# **KEMPS CREEK ESTATE – SSD-9522 MOD 3**

Amended Development Report

Prepared for  
**FRASERS PROPERTY INDUSTRIAL &  
ALTIS PROPERTY PARTNERS**  
29 August 2022

Figure 4 Proposed amendment to SSD-9522 MOD 3 – Site Layout Plan

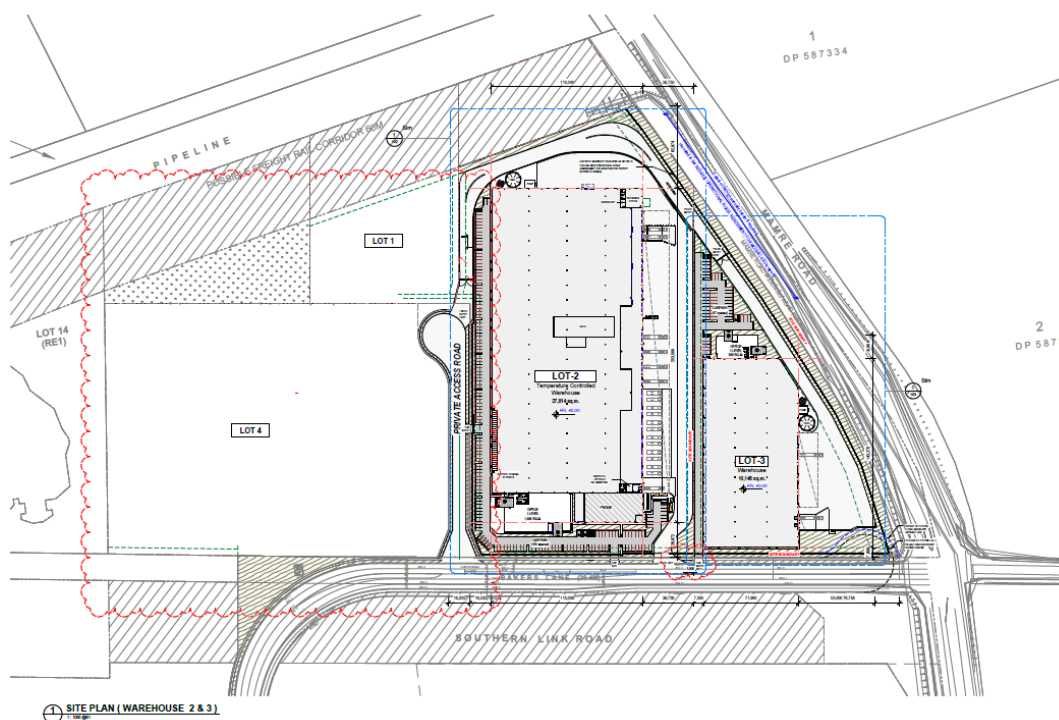
The amendment to SSD-9522 MOD 3 consists of the construction and use of warehouses 2 and 3 for the purposes of warehouse and distribution centres. The design and layout of warehouses 2 and 3 remain unchanged, with the detailed descriptions provided in the sections below.

Figure 5 Warehouse 2 Site Plan

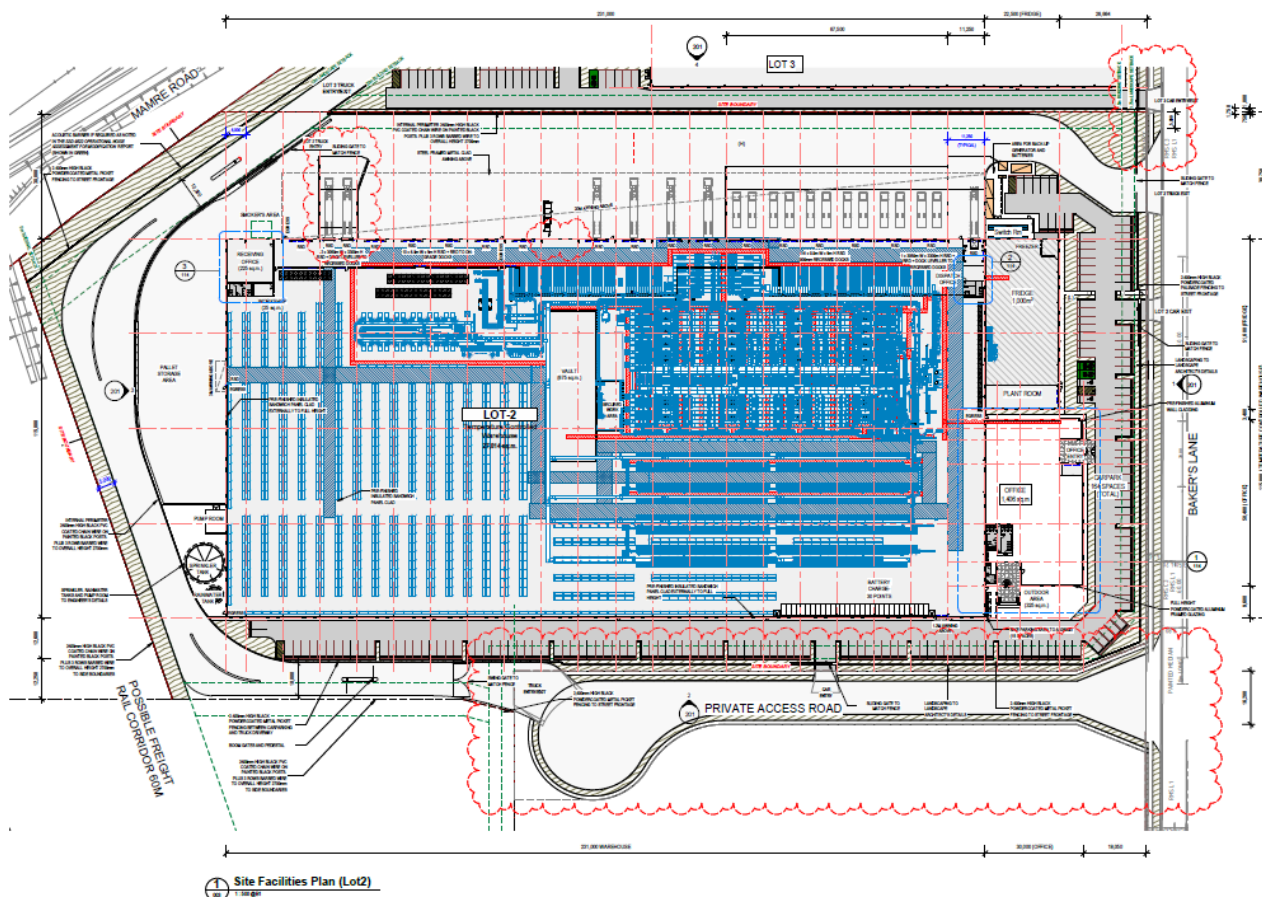
Warehouse 2 is bound by a truck accessway to the north, through which trucks enter the hardstand area through a set of sliding gates along the western boundary of the site. Trucks exit Lot 2 through an access point on Bakers Lane which only services Lot 2. Cars enter Lot 2 through the cul-de-sac road and exit through separate access point on Bakers Lane. Lot 2 and Lot 3 are the only lots which have direct access to Bakers Lane which are exit only and separated for cars and trucks.

The layout for Warehouse 2 is directly based on specific customer specialised fitout and operational requirements. The north-south orientation is the most efficient outcome from a series of alternatives assessed for the wider Estate as it also includes extensive automation which meets the operational requirements of the tenant. The proposed configuration of Lot 2 and Warehouse 2 also minimises the number of driveways connecting to/from Bakers Lane which is a key consideration in satisfying Condition B18.

There is a decrease in building height for Warehouse 2 under MOD 3, which consists of an 11.4m reduction within the eastern portion of the site. This is also accompanied by a reduction in pad levels within Lot 2.

The Lot 2 interface with Mamre Road will be defined by a 3m high acoustic wall to mitigate noise from the hardstand area to the east of Warehouse 2. This acoustic wall is required to mitigate sleep disturbance impacts to the residential dwelling at 654-674 Mamre Road (receiver R2) and will be screened by landscaping to ameliorate visual impacts. The acoustic wall will only be required if the residential dwelling is

Figure 6 Warehouse 3 Site Plan

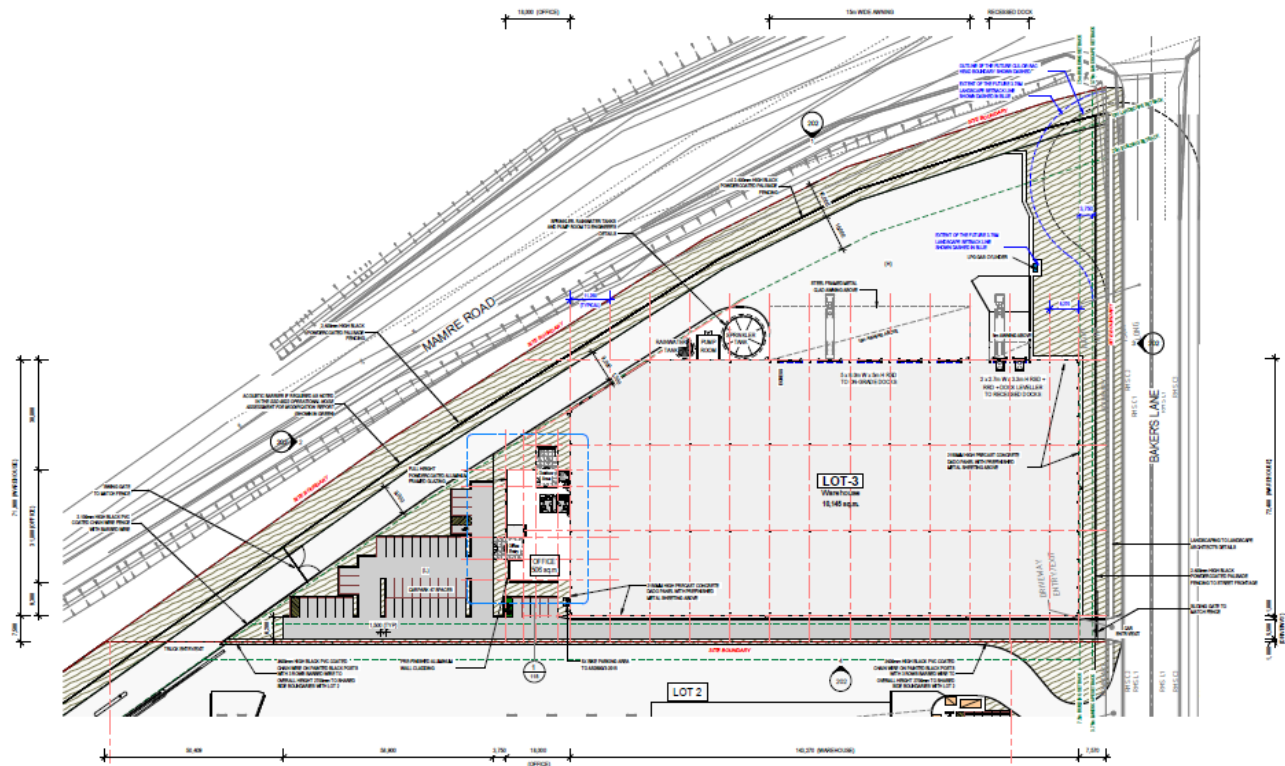
Access to and from the Warehouse 3 car park is provided off Bakers Lane, which together with access points for Lot 2 are the only direct access points off Bakers Lane. Truck access to and from the hardstand area of Warehouse 3 is provided from the driveway at the end of the private access road. This driveway is shared between Lots 2 and 3.

Lot 3 provides a buffer zone, which is to be characterised by landscaping, within the south-eastern corner of the lot to cater for the transition of Bakers Lane to be a cul-de-sac road, once its connection to Mamre Road is removed. There is sufficient set back space provided for the future turning head at the end of Bakers Lane.

The building heights for Warehouse 3 remain unchanged under MOD 3, being proposed at 13.7m. The pad levels also remain unchanged from what was previously approved on Lot 3.

A portion of the Lot 3 interface with Mamre Road, along the car park, will be defined by a 3m high acoustic wall to mitigate noise from the hardstand area to the east of Warehouse 2. This acoustic wall is required to mitigate sleep disturbance to the residential dwelling at 654-674 Mamre Road (receiver R2) and will be screened by landscaping. The acoustic wall will only be required if the residential dwelling is still occupied once Warehouse 2 is operational, or if it is planned for residential purposes in the future once Warehouse 2 is operational (refer to Noise Impact Assessment in **Appendix D**).

Figure 8 Previously exhibited layout for SSD-9522 MOD 3 – Site Layout Plan

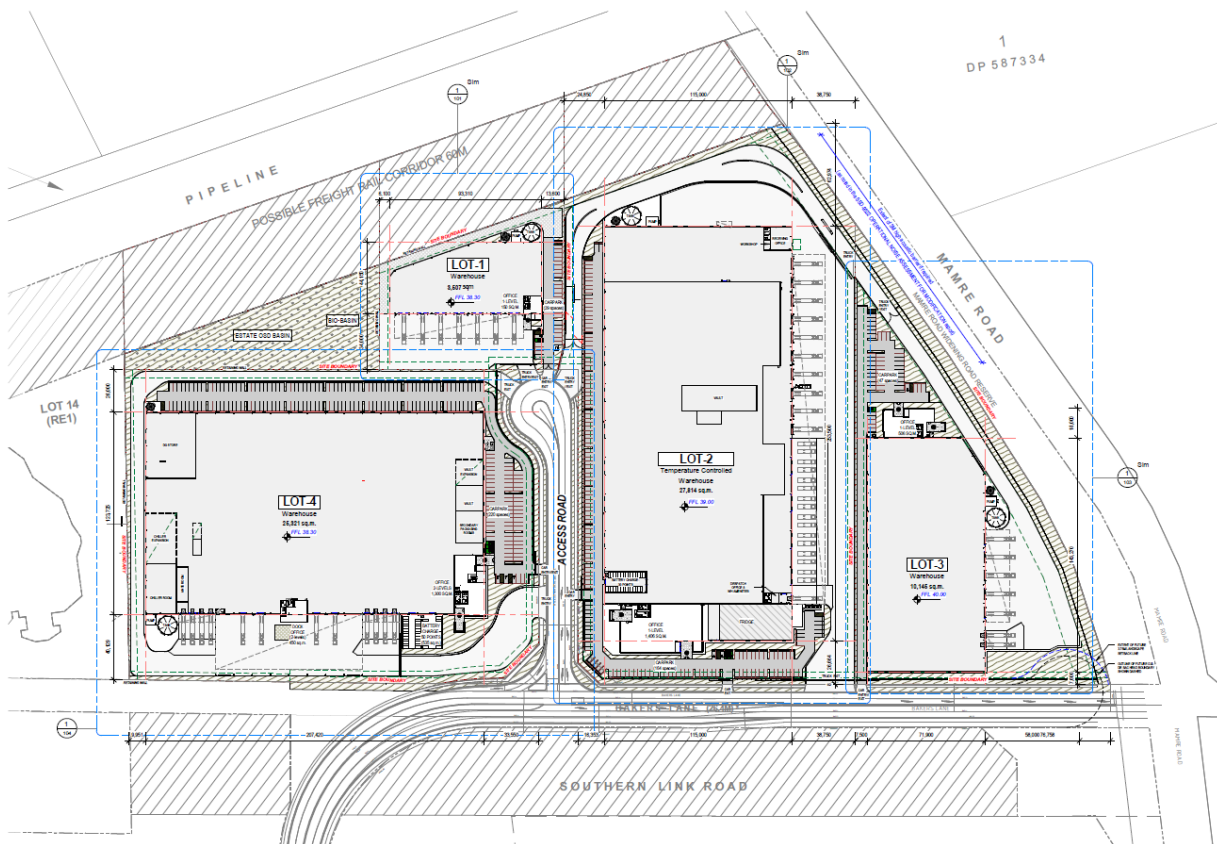
The site layout plan for SSD-9522 MOD 3 exhibited by DPE comprised a total of four (4) warehouses within Lots 1-4 (refer Figure 3) and a new north-south one-way directional access road off Bakers Lane.

Figure 9 Updated Bulk Earthworks Plan for Lots 1-4 under MOD 3

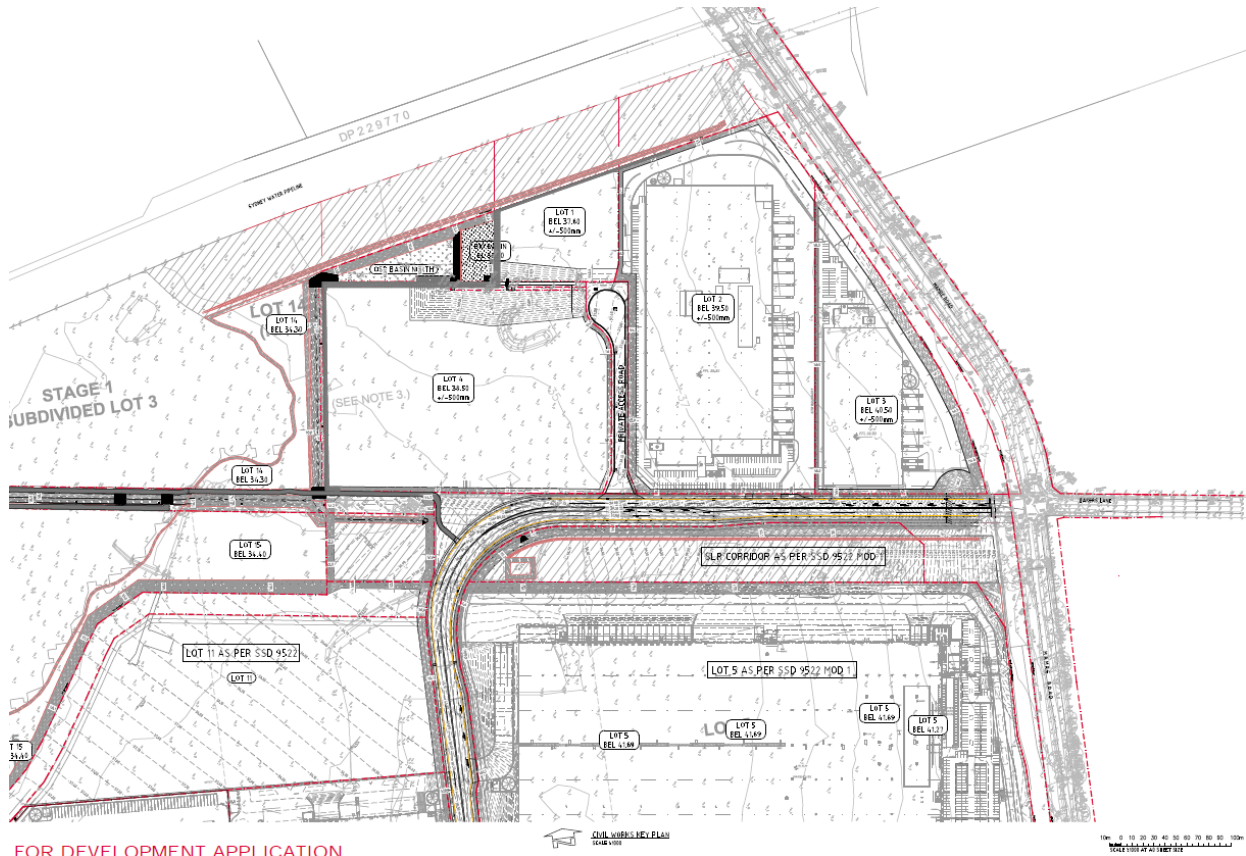
- Removal of on lot works and built form within Lots 1 and 4 from MOD 3, with only on lot works and built form to remain within Lots 2 and 3 as part of the amended MOD 3. Bulk Excavation Levels and benching across Lots 1-4, however, remain unchanged and to be retained as originally proposed in MOD 3 (refer Figure 9).

Figure 10 Private Access Road arrangement proposed under the revised MOD 3 (outlined in red)

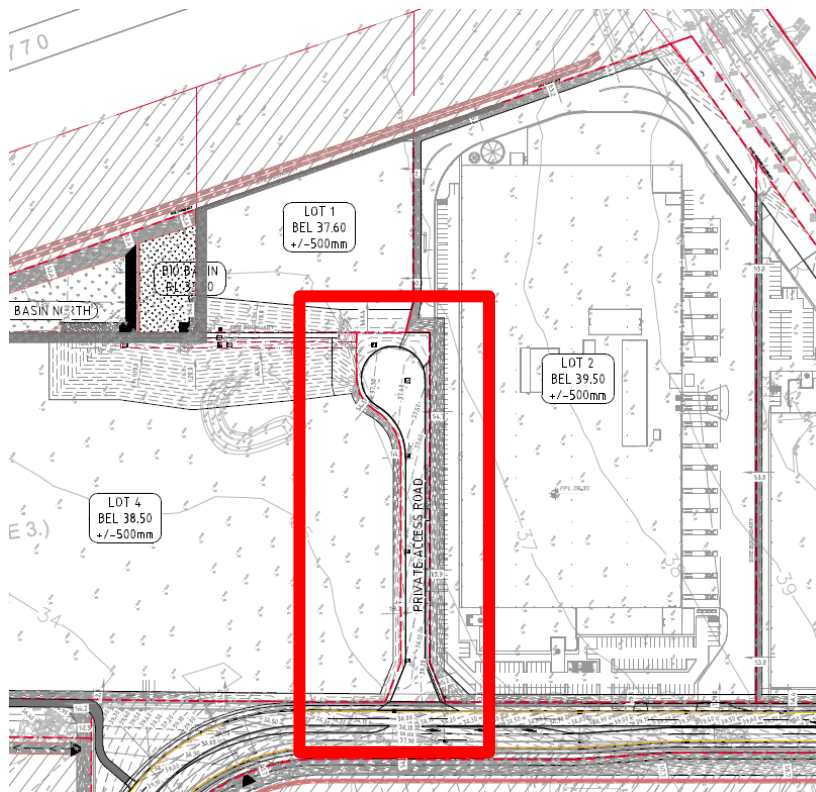
MOD 3 originally proposed a one-way cul-de-sac road off Bakers Lane, with one-way circulation, to serve Lots 1-4. This design and location of the access road was not supported by TfNSW. The amended MOD 3 site layout plan seeks to reconfigure this as a private access road. The road will be:

- 10m wide
- 184.3m long
- 16.5m turning head radius

It will facilitate access to and egress from the Lot 2 and Lot 3 access driveways at the northern end of the turning head.

Figure 16 Proposed external vehicular access

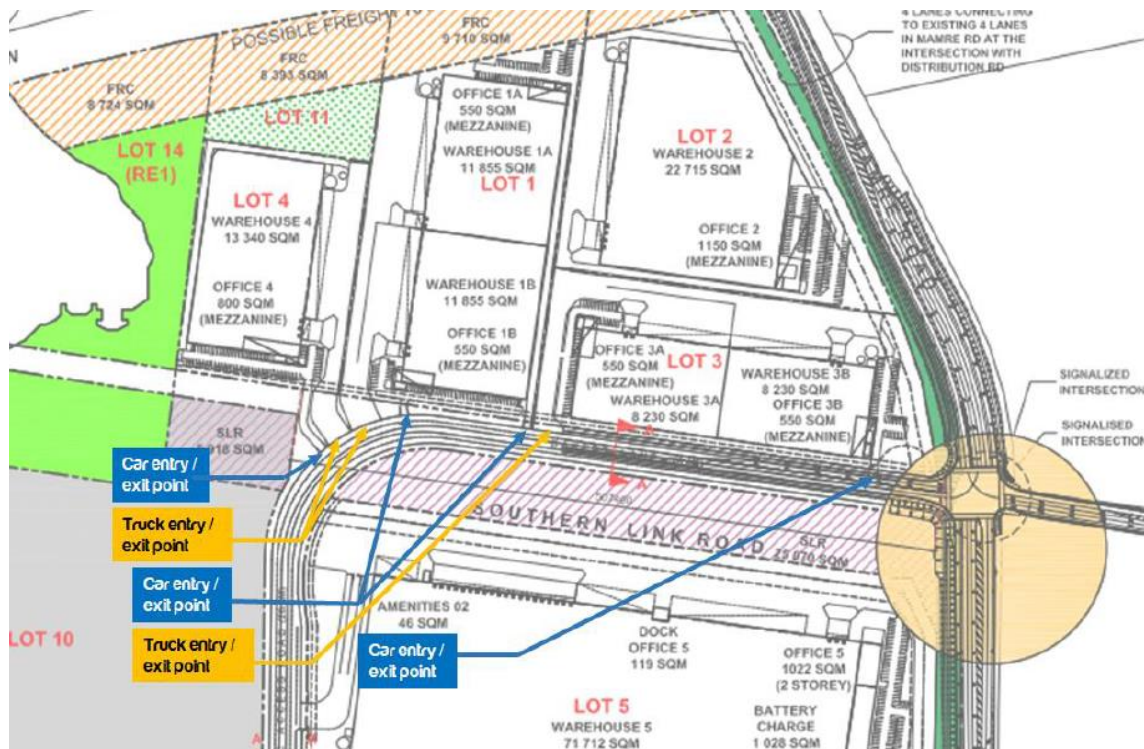
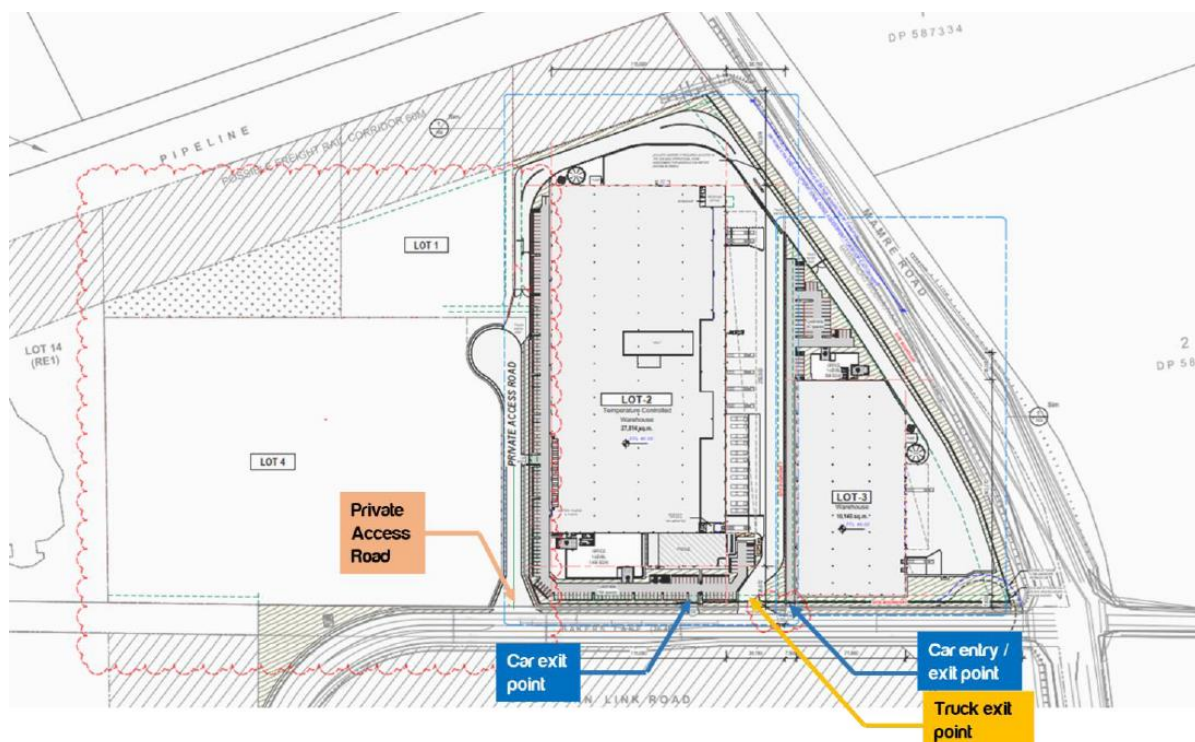
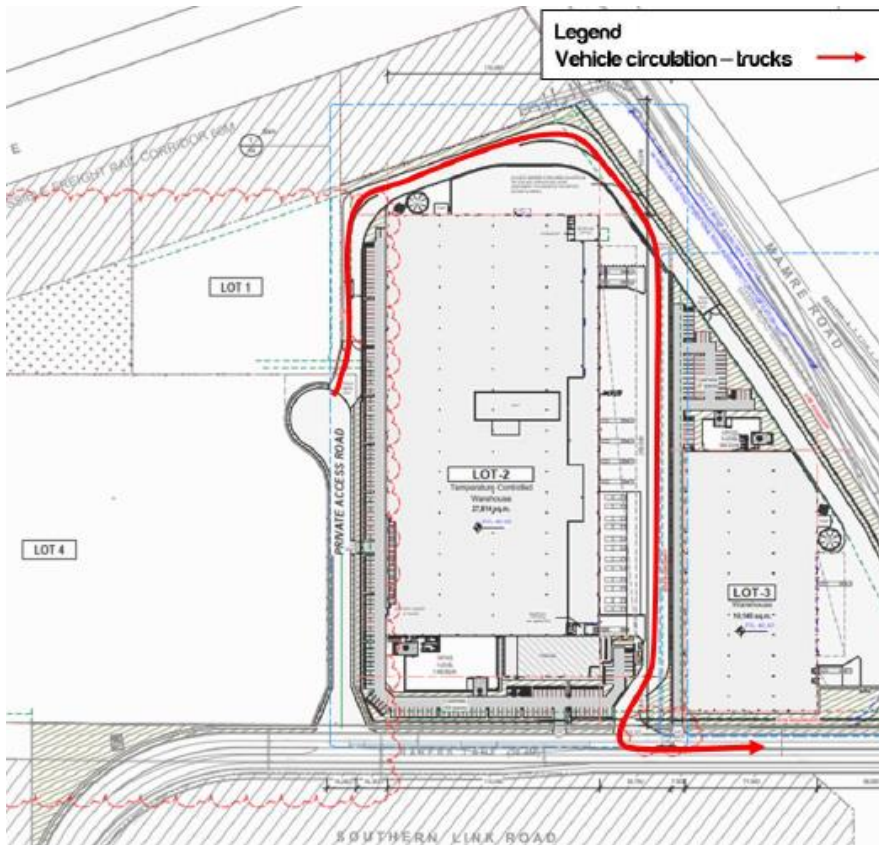
The amended MOD 3 layout reduces the vehicular access points along Bakers Lane from what was originally approved under SSD-0522. The new north-south private access road terminates into a turning circle, and has a one-way directional flow, providing safety for vehicle access and egress.

The inclusion of an access road off Bakers Lane provides access to Lots 1-4, reducing the access points along Bakers Lane from seven (7) to four (4) (refer **Figure 15** and **Figure 16**). The proposed modification also removes driveway access previously proposed adjacent to the Southern Link Road which directly impacted on the future signalised intersection with Bakers Lane. The access road enables the reduction in access points and provides the internal road network to Lots 1-4 in response to Condition B18. The private access road is proposed at a suitable distance from the future intersection at 140m, which meets the minimum requirement of 100m separation from TfNSW.

Figure 20 Extent of acoustic barrier to mitigate potential sleep disturbance impacts at receiver R2

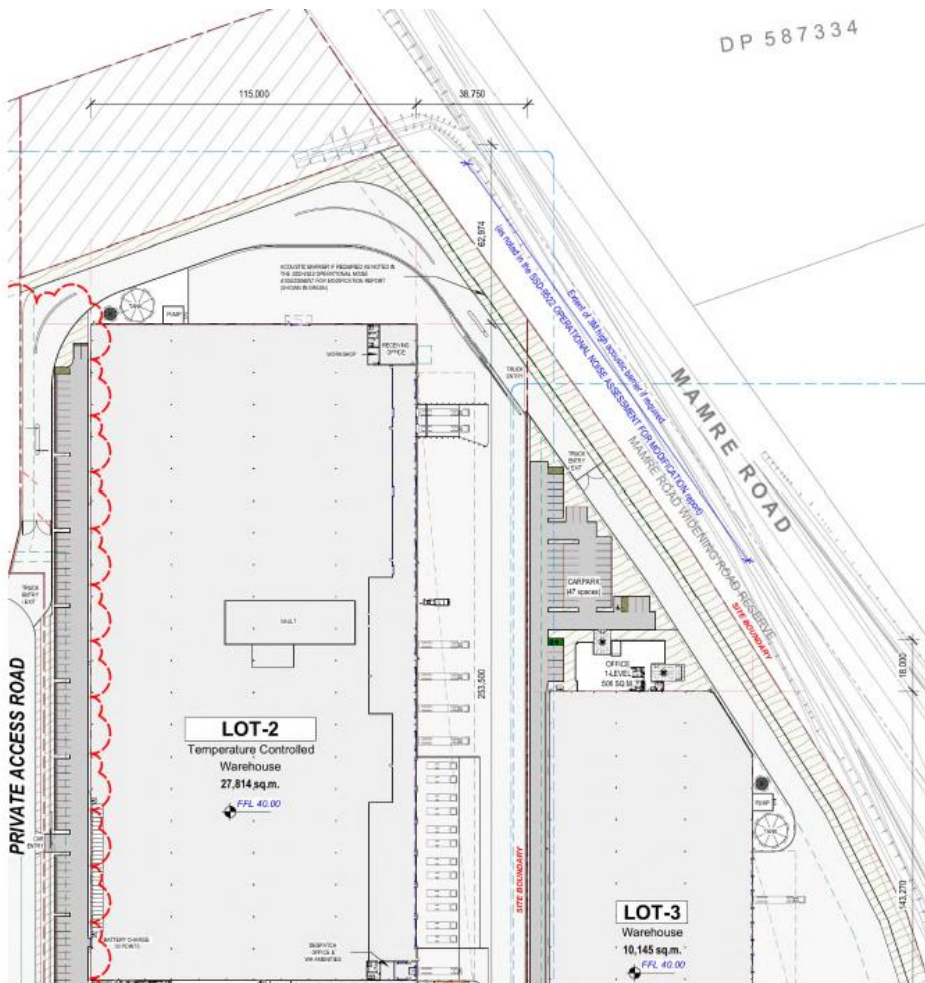
As such, noise mitigation and management measures are identified to address the predicted sleep disturbance impacts including the installation of a 160m long and 3m high noise wall along the eastern boundary of the site along the Mamre Road frontage. Provision is to be made for installation of the barrier as shown in **Figure 20** in order to successfully mitigate sleep disturbance impacts for receiver R2. The noise barrier is not required in order to meet the sleep disturbance criteria for all other receivers.

Installation of the noise wall is only required should the residence at the R2 receiver be occupied at the commencement of operations in Lot 2. If the dwelling at R2 is not occupied at the time of operation for Lot 2, and/or is not planned to be occupied for residential purposes in the future, the barrier is not required as there will be no sleep disturbance impact to an unoccupied dwelling.
